**MASTER DRAINAGE STUDY
UPDATE #3
(SUPPLEMENT to CLV CONDITIONS)**

Skye Canyon
City of Las Vegas, Nevada

**Subject: Master Drainage Study Update #3 for Skye Canyon (DS4420)
Supplement – Response to City of Las Vegas Conditions of Approval**

This letter is submitted in response to comments contained in the August 15, 2016 conditional approval letter received from City of Las Vegas (CLV) regarding the above referenced project. A copy of the CLV conditional approval letter is included in Appendix A for reference. The following comments have been individually addressed:

EXHIBIT D
SHEET 1 OF 1

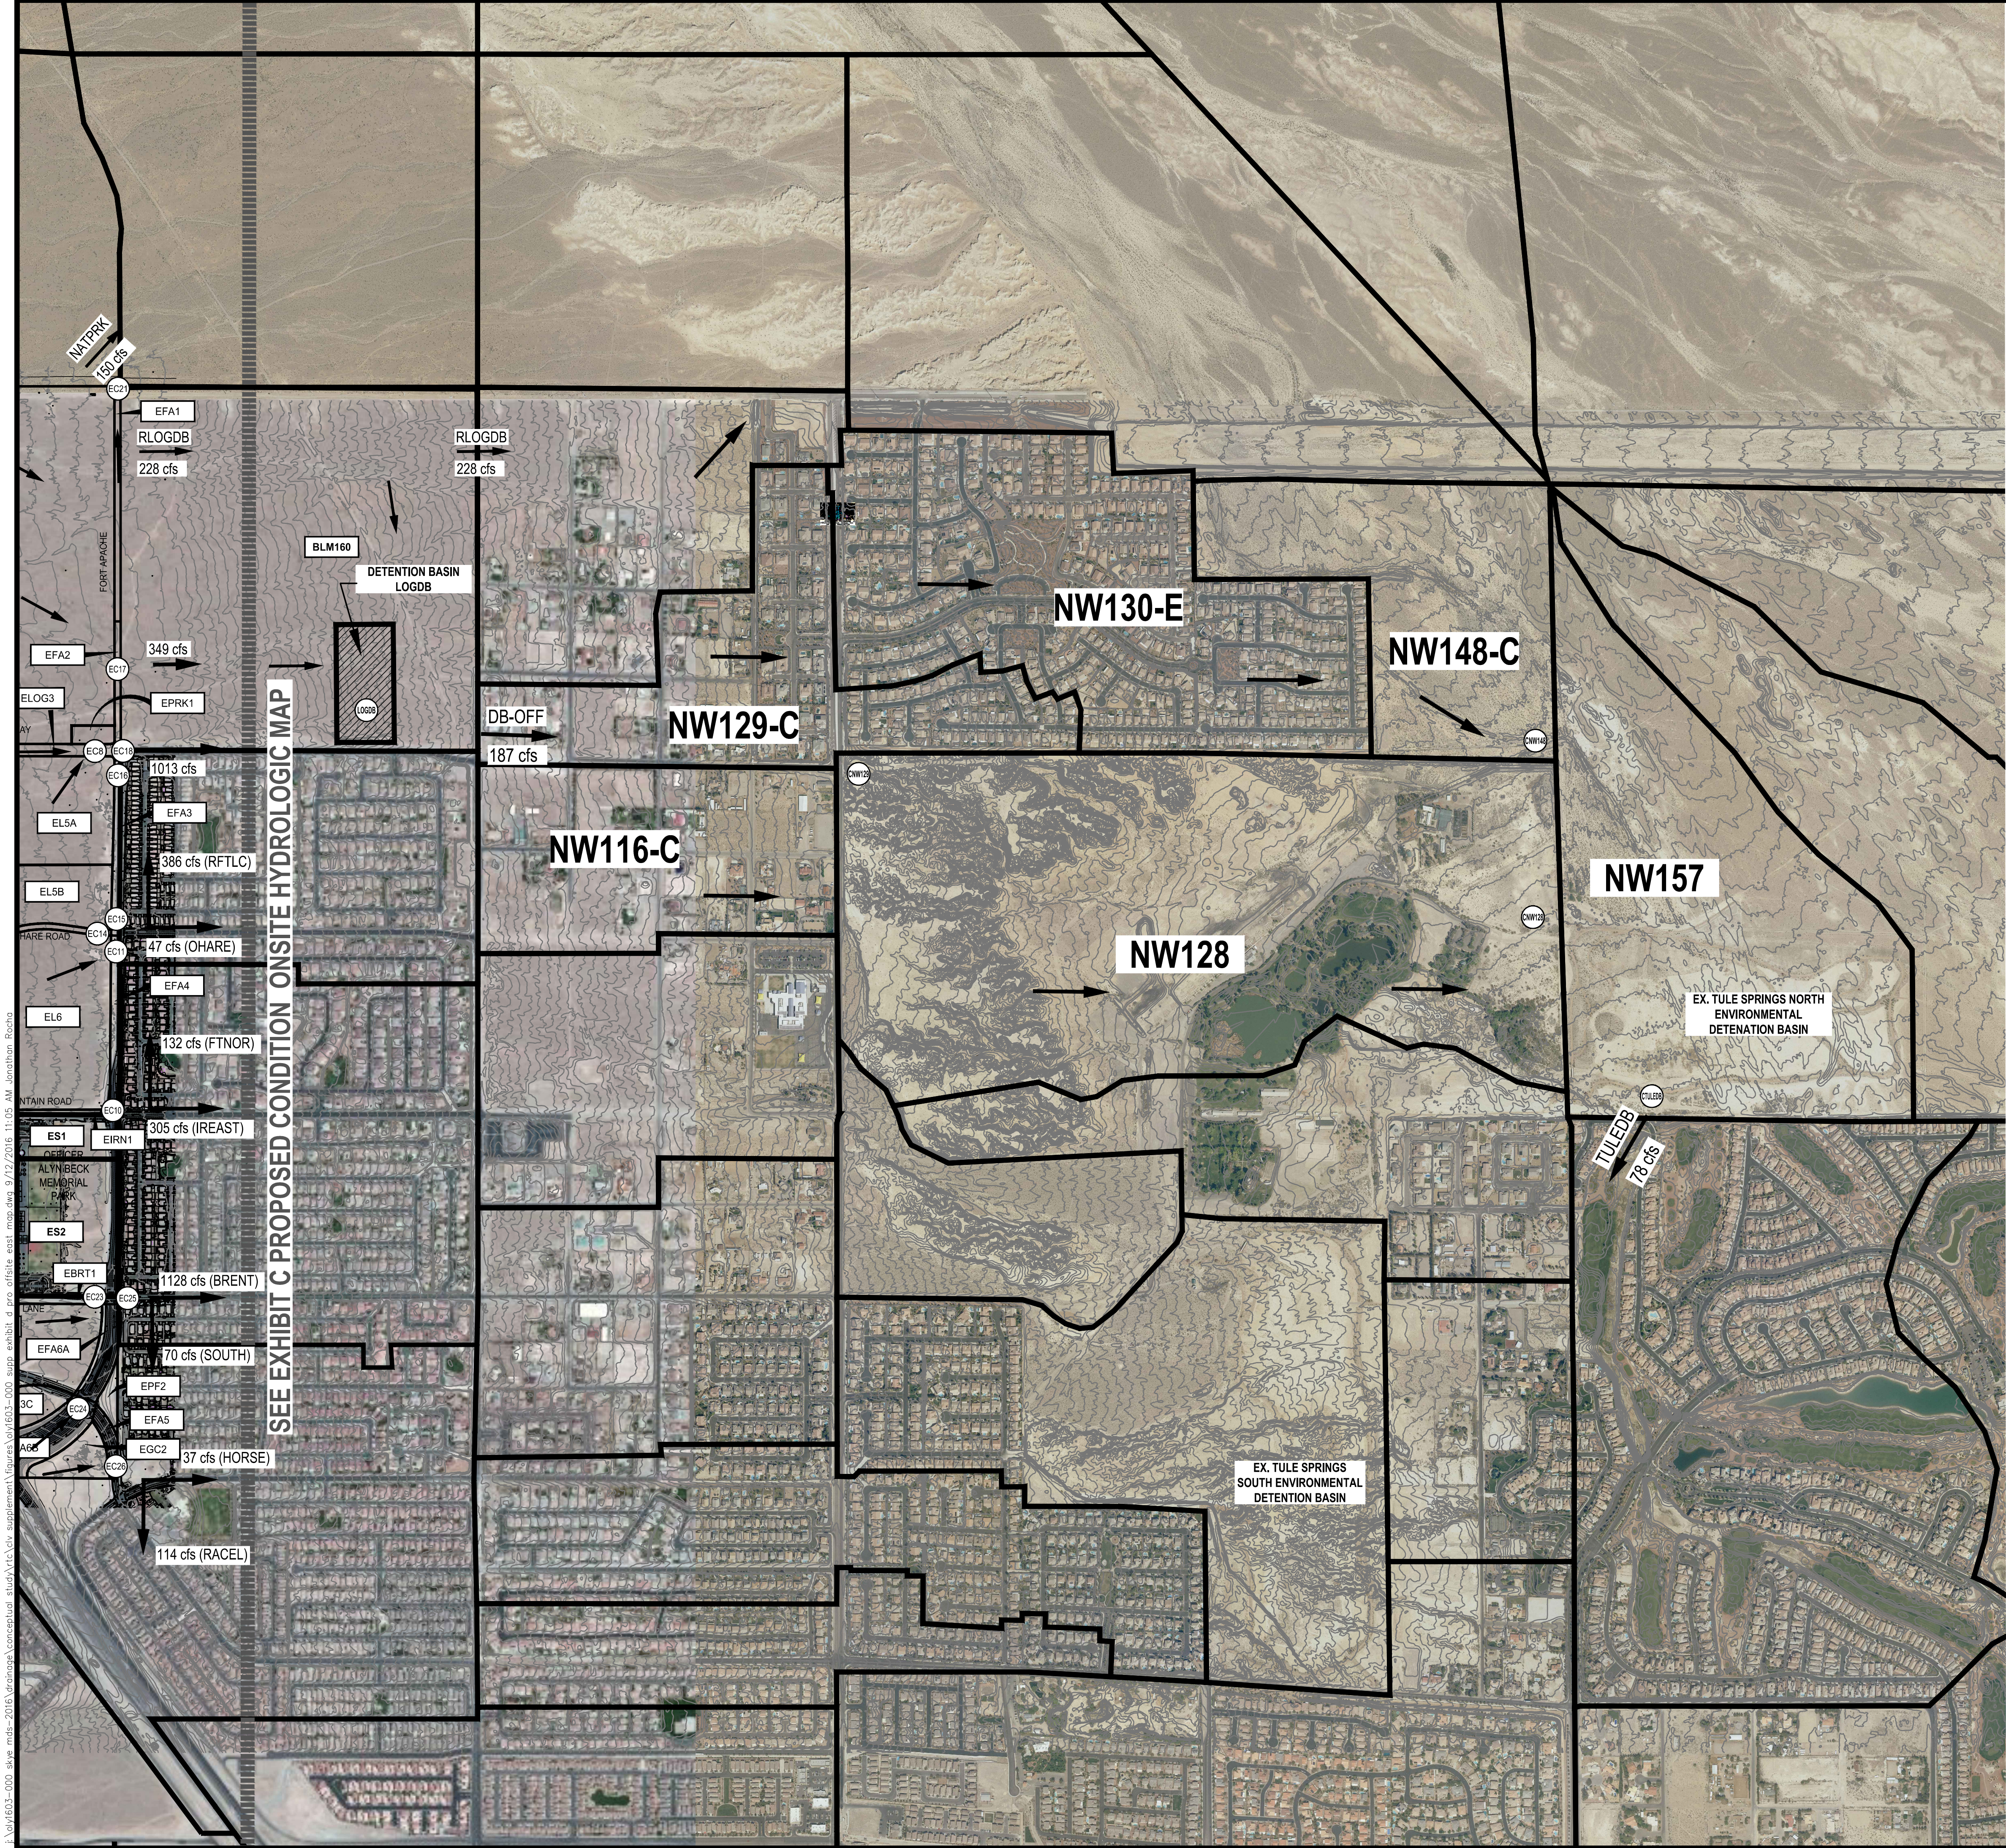
4. **Comment:** *This Update proposes to construct the Log Cabin Detention Basin #3 with flows that will increase the runoff volume routed towards the Tule Springs North Environmental Detention Basin (TSNEDB). The engineer proposes to modify the TSNEDB by removing the orifice plate at the detention basin outfall pipe to increase the outflow. Detention basin design uses the orifice plate to insure that the basin outfall remains under inlet control parameters per the HCDDM, Section 1200. Discuss the impact of removing the orifice plate and provide calculations verifying that the existing outfall will convey the proposed 78 cfs under inlet control conditions. Discuss the drain time impacts to the TSNEDB and the impacts to the downstream development. Alternatively, the TSNEDB may need modifications to meet the HCDDM requirements. This could include the expansion of the TSNEDB basin to increase the storage volume accordingly or replacement of the TSNEDB outfall. These or other modifications need to be conceptually addressed as supplemental information prior to the MPA approval.*

Exhibit D: The summary tables entitled "Offsite Concentration Points" and "East Diversions" have been updated to reflect the change in outflow from the North Environmental Detention Basin, per Response to Comment No. 4. Flow areas summarizing hydrologic routing through Subbasin 'BLM160' are more prevalent for clarification. The 100-year flow value shown in plan view at the outlet of the North Environmental Detention Basin has also been updated per Response to Comment No. 4. No other changes have been performed, all other hydrologic flow rates remain as previously presented.

EXHIBIT H
SHEET 1 OF 1

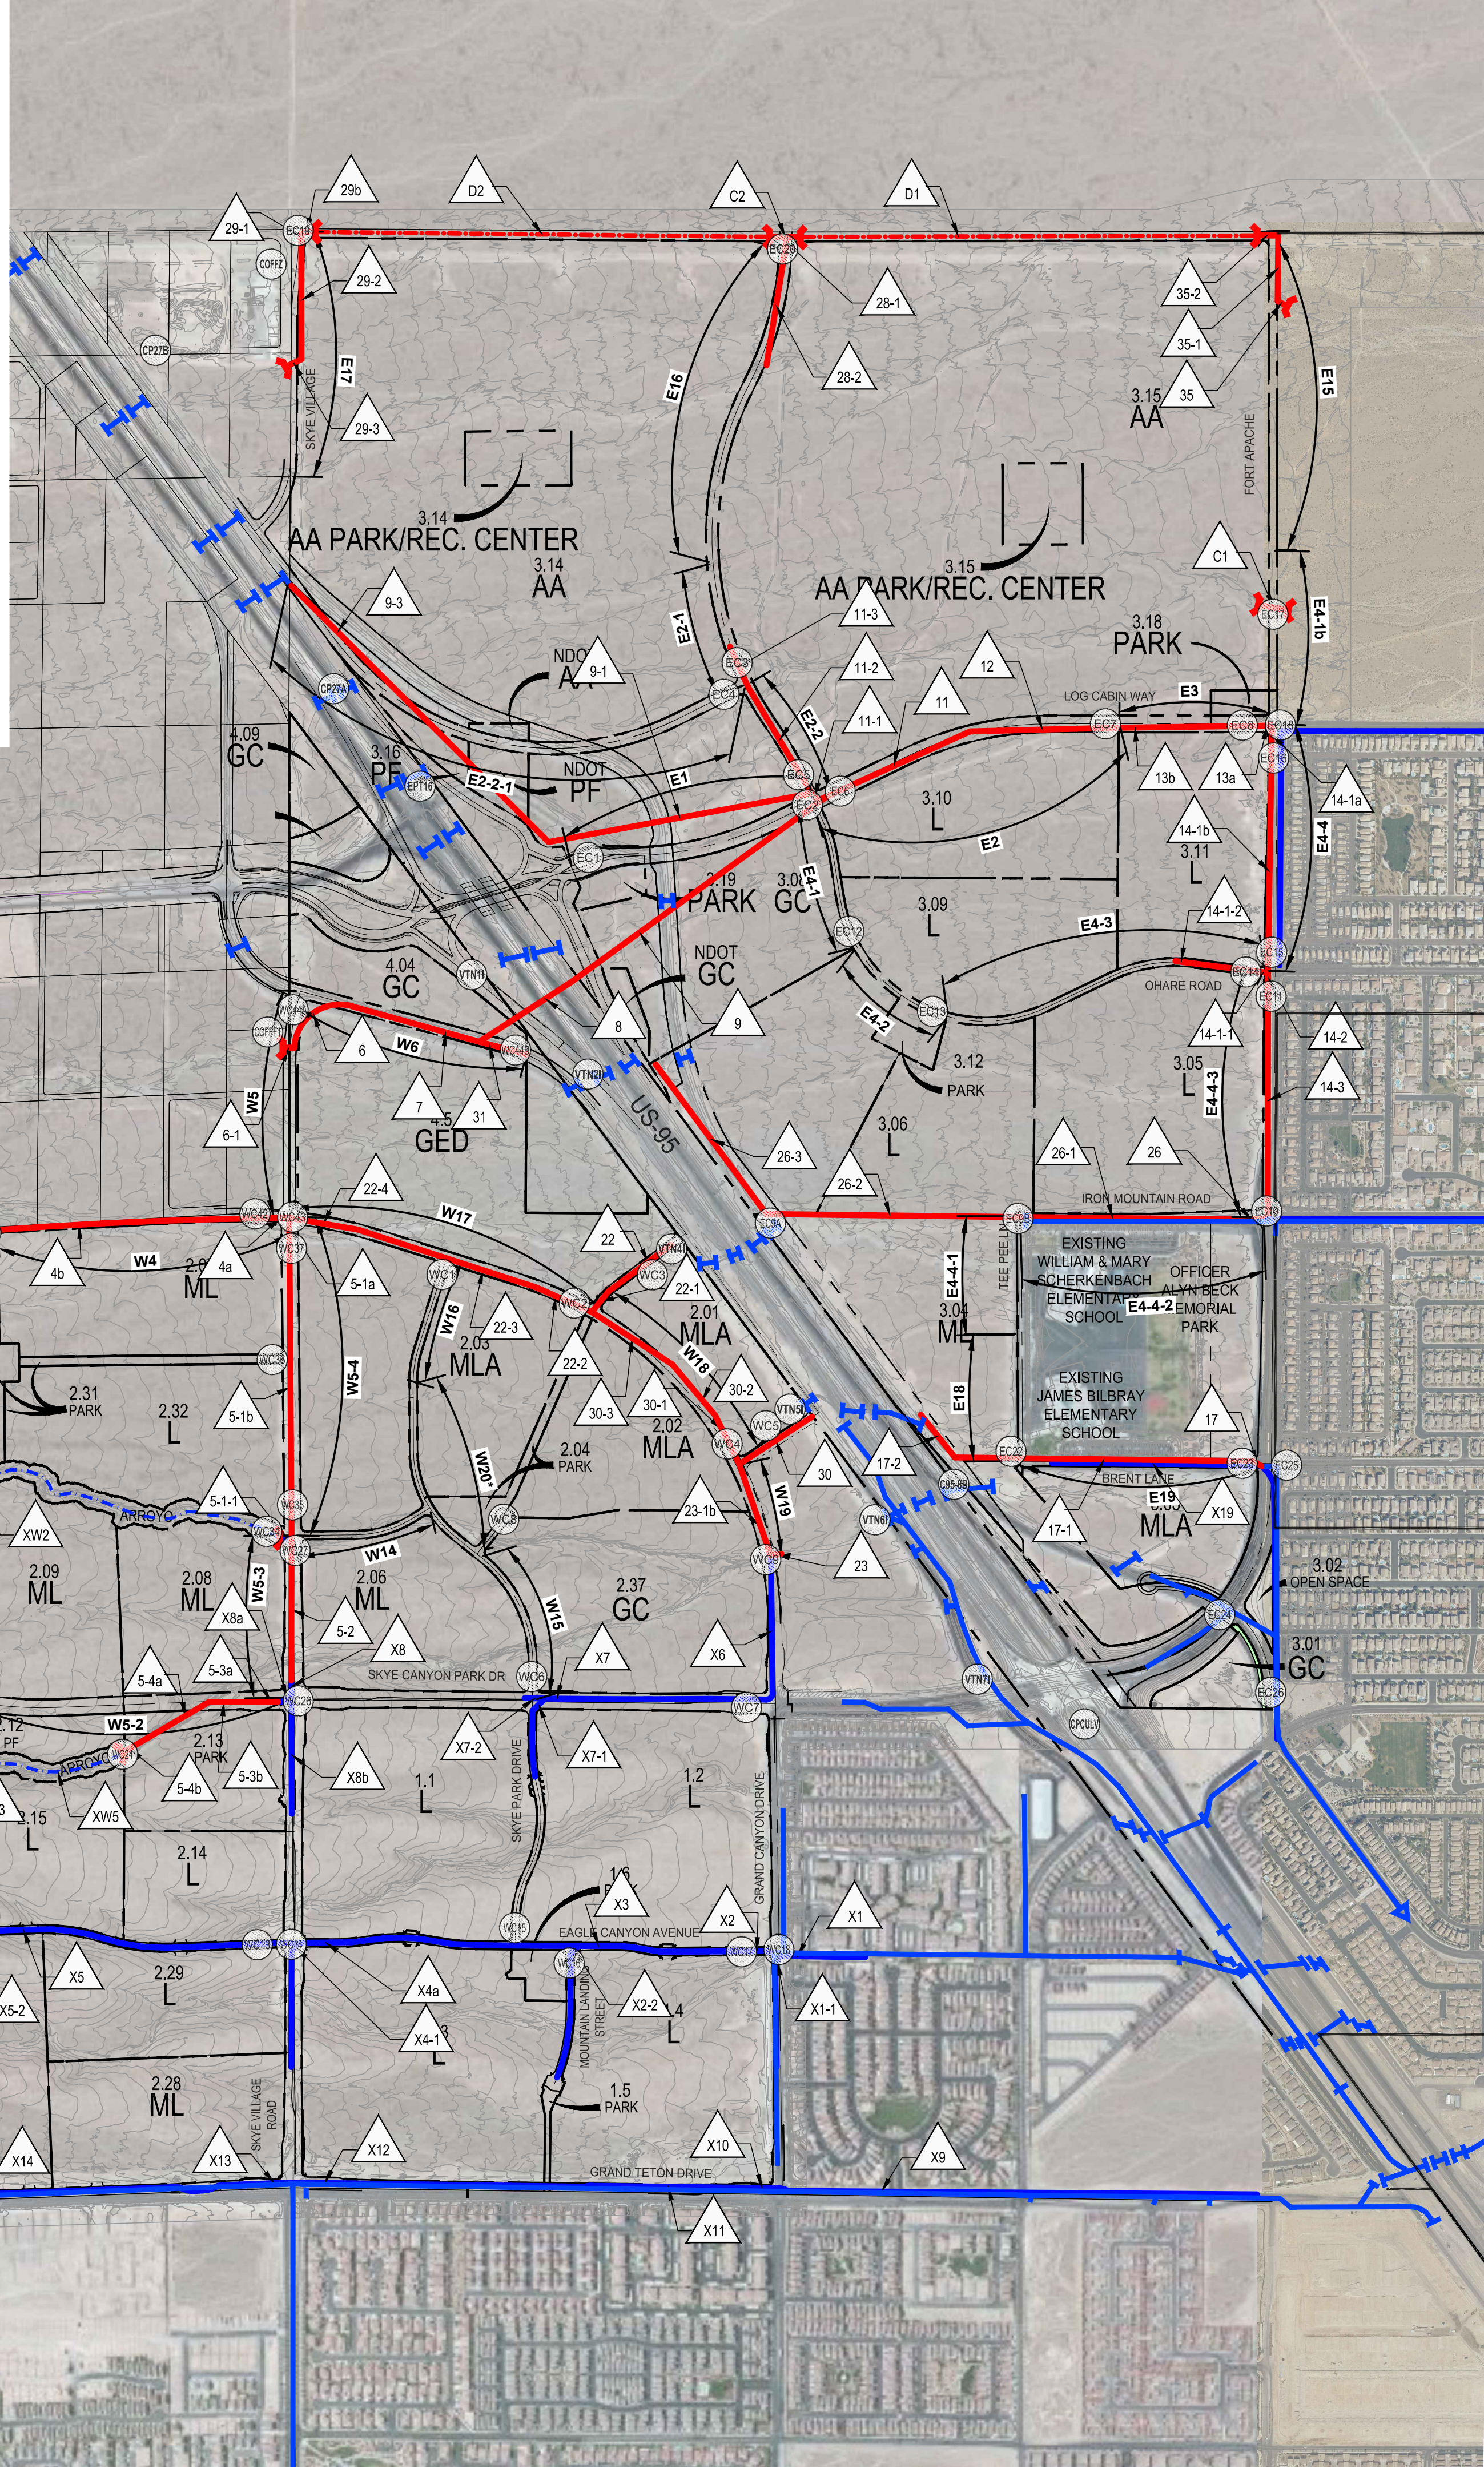
7. **Comment: Exhibit 1:** *The developed condition Exhibit 1 shall be updated to include the coordinated Kyle Canyon Interchange drainage improvements. The size of the downstream facilities shall be reviewed based upon the interchange improvements.*

11. **Comment:** *Exhibit J: The proposed changes to DB1 will impact the alignment and size of the ultimate collection facility that drains to DB1. The proposed facility shall remain an open channel to allow flow interception from the west in this undeveloped drainage.*

Response: The proposed (Exhibit H) and ultimate (Exhibit J) condition onsite drainage facilities exhibits have been updated to reflect the storm drain size and alignment concepts presented in the Hydraulic Supplement that SHG prepared for the Kyle Canyon and US-95 Interchange project. The concept's summary exhibit and preliminary storm drain profiles have been included in Appendix D for reference.

Response: Exhibits H and J have been adjusted to show the changed alignment of the collector channel, Facility 'XC5'. Facility 50 has been adjusted to a future open channel to be constructed by others as described above in Response to Comment No. 10.
